# **Smart Construction Retrofit v1.7.1 Update details**

## In addition to conventional RTCM, CMR/CMR+ can now be received.

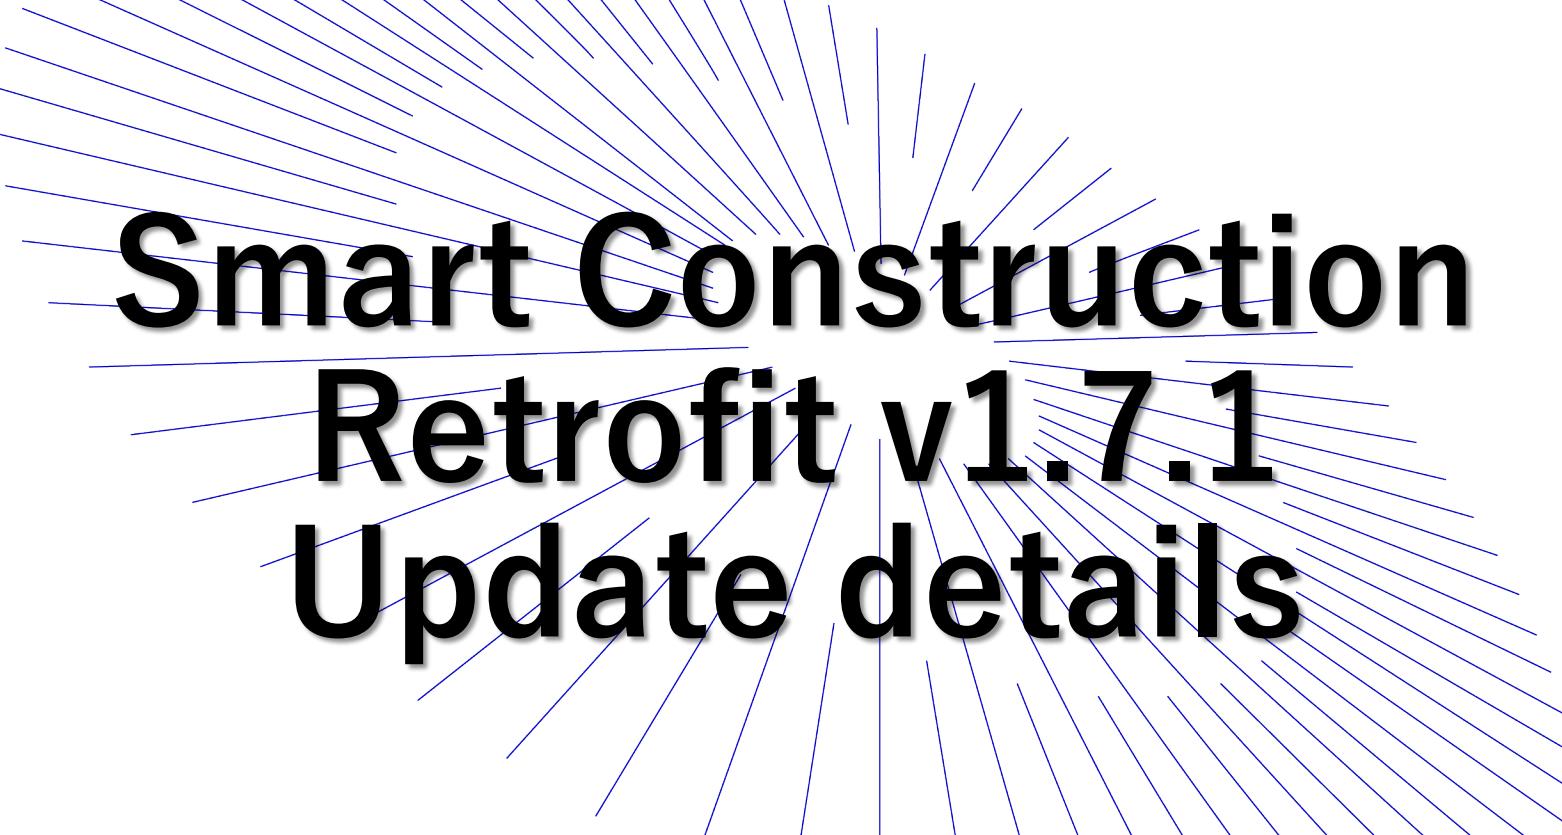
If using CMR/CMR+, change the GNSS settings in the Pilot tablet app (v1.0.04 or higher).  
If reception is not possible, try a controller reboot or Soft / Hard Reset.
